Fw: S. 16 Planning Application No. A/YL-KTN/1157 - Departmental Comments A-YL-KTN-1157 15-9-2025.pdf

有關漁農自然護理署對 A/YL-KTN/1157 的查詢

A/YL-KTN/1157 Drainage proposal comment

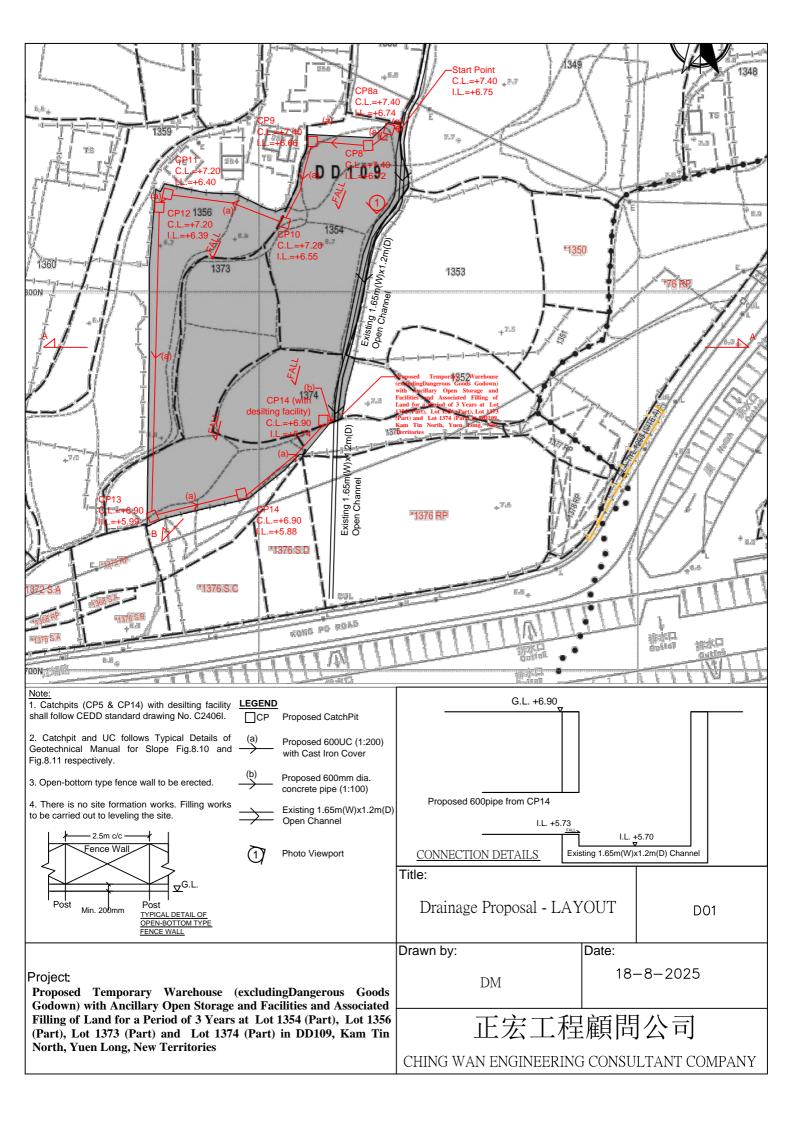
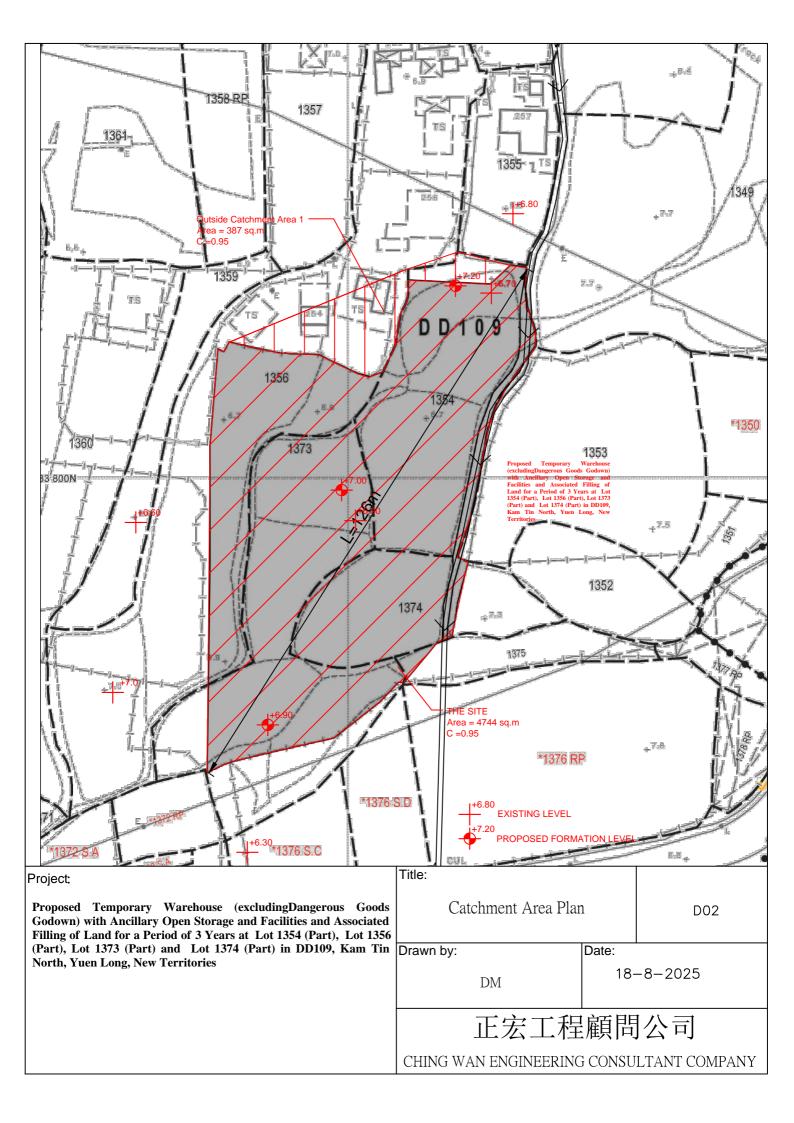
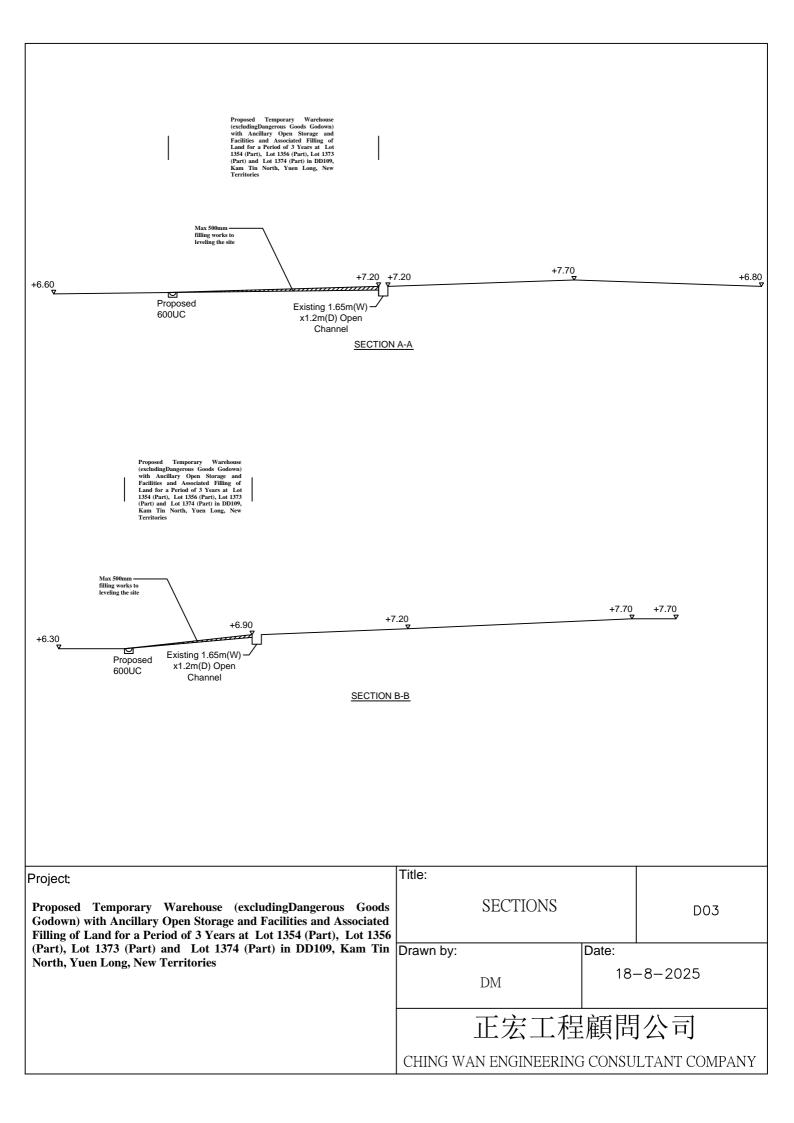
- 2. (A)
- (i) Noted.
- (ii) There is no existing watercourse that area. The only existing drainage is at the east side of the application site.

- (iii) External catchment area from the north of the site has been considered. The runoff from east and southeast of the site would not pass through the site because there is an existing 1.65m(W)x1.2m(D) open channel in between.
- (iv) Cross sections are provided.
- (B)
- (i) It is indicated.
- (ii) Peripheral channel has been provided. The minor filling works that aims at leveling the site would not obstruct any overland flow.
- (iii) Hydraulic calculation checking the proposed 600UC and 600pipe is provided.
- (iv) Hydraulic calculation checking the existing 1.65m(W)x1.2m(D) open channel is provided.
- (v) The design flow velocity is presented in the calculation and all are within the range 0.75 m/s to 3.0 m/s.
- (vi) Noted.
- (C)
- (i) Noted.
- (ii) Noted.
- (iii) Noted.

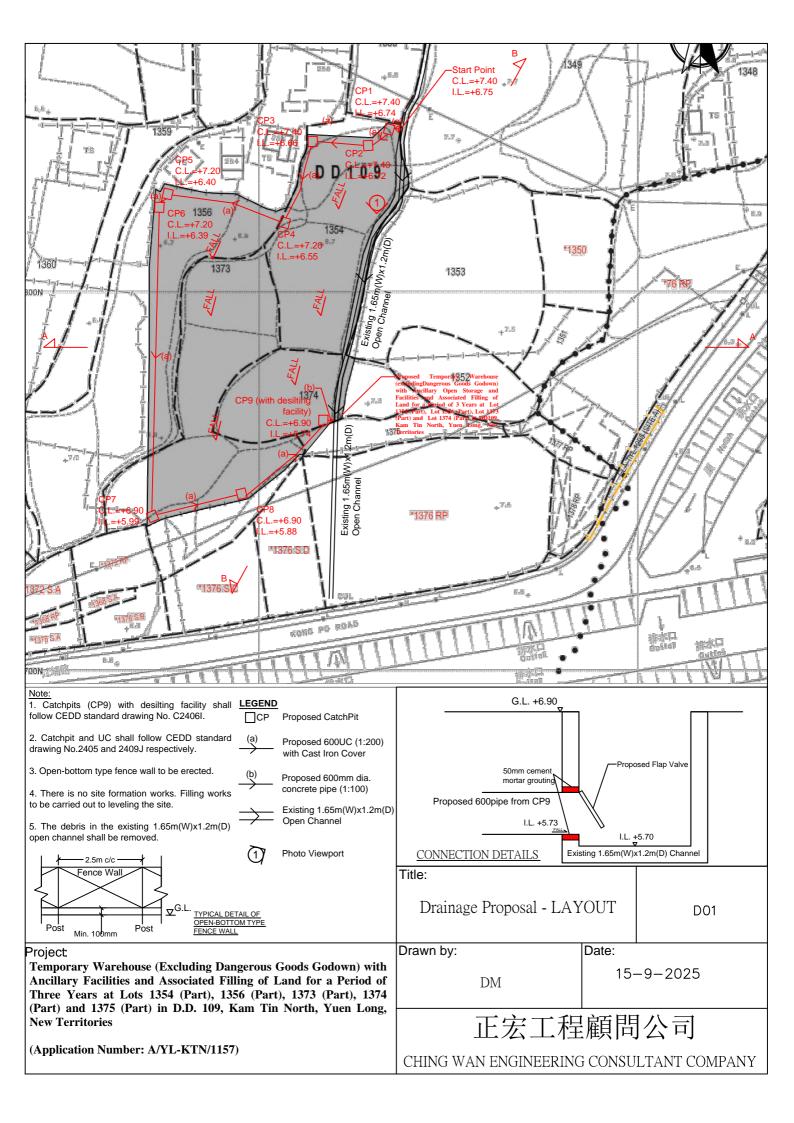
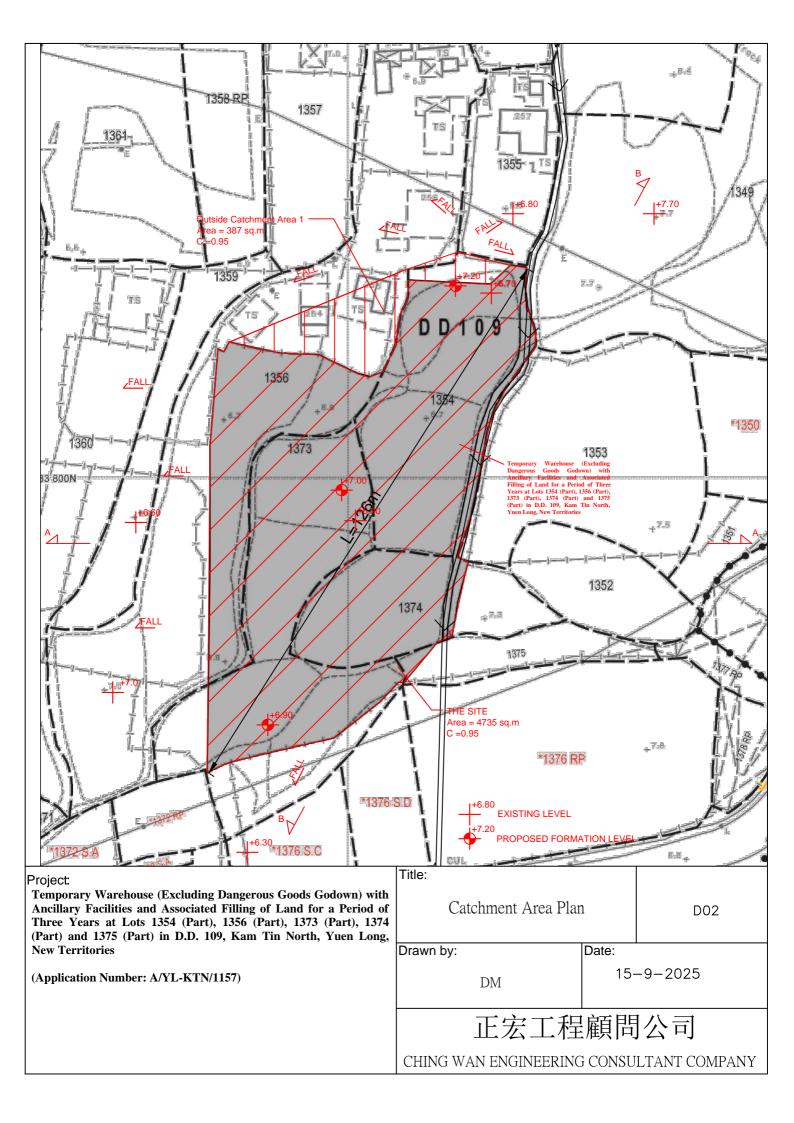
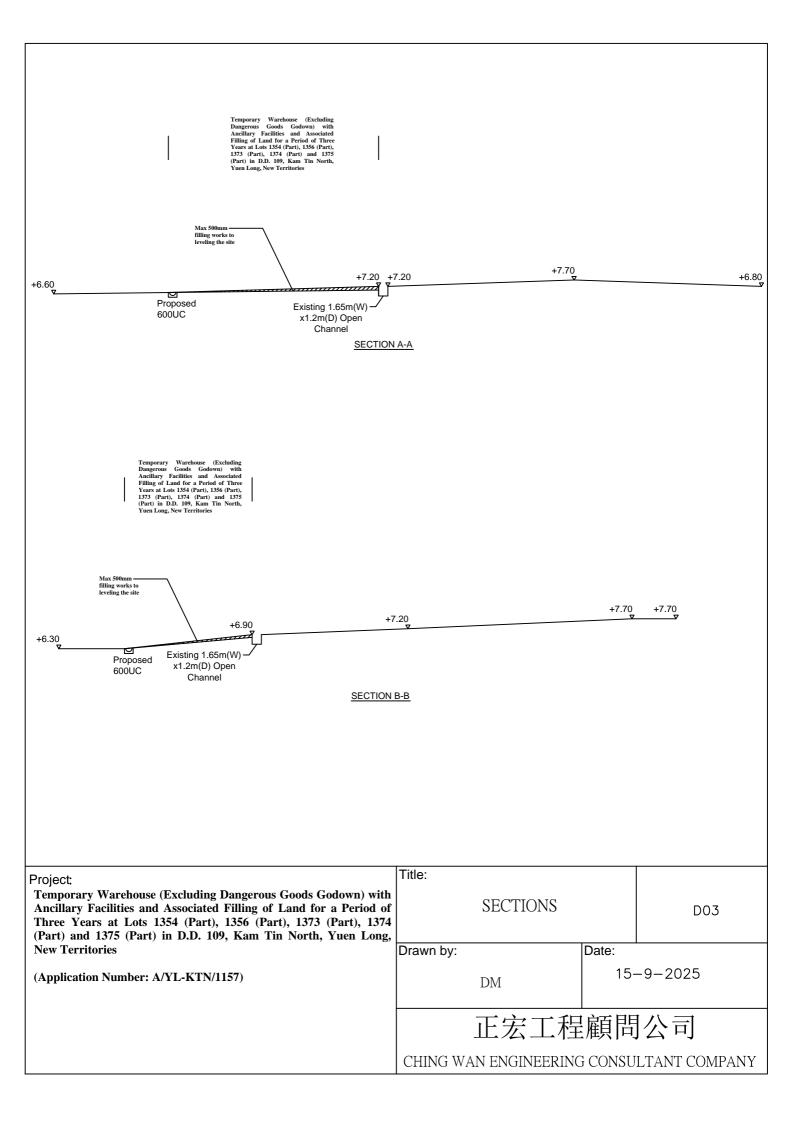
- (D)
- (i) Typo, it is revised.
- (ii) Cement grout is provided in the connection to prevent the leakage at the proposed connection.
- (iii) Flap valve is proposed to prevent backflow.
- (iv) CEDD standard details are followed in this submission.
- (v) The debris in the existing 1.65m(W)x1.2m(D) open channel shall be removed, this is stated in the Notes.
